Access Compliance Report Public Rights-of-Way (Curb Ramps)

Main Street: CHAPMAN_AVE Cross Street: CRAWFORD_CANYON_RD Location: SE

ADA ID: RPRK211007171520 Ramp Type: Type 1 - Perpendicular Diagonal Initial Pass/Fail: Fail Overall Compliance: No Severity Score: 15

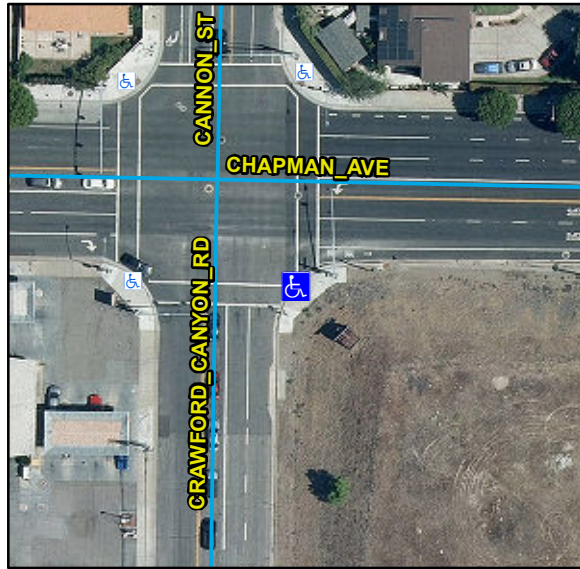
R304.2.2, R204.3, STD 1115

Remove & Replace Curb Ramp With Two New Directional Ramps or Equivalent.
